Objective: This week's issue will cover the following subjects.

- New Chamber Door Handle
- New larger water trap

New Chamber Door Handle

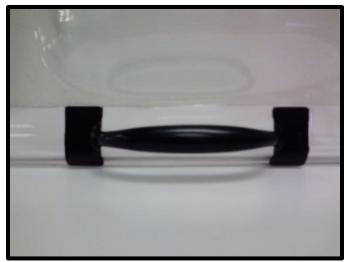
- The new door handles are now being installed on all new chamber doors being shipped to the field for replacement.
- The new handle is adhered by 2-sided tape instead of 2 screws. This should prolong the life of the door, virtually eliminating the cracks formed by the original style handle and screws.
- The original handle and hardware should be left on site in case the new handle comes off.
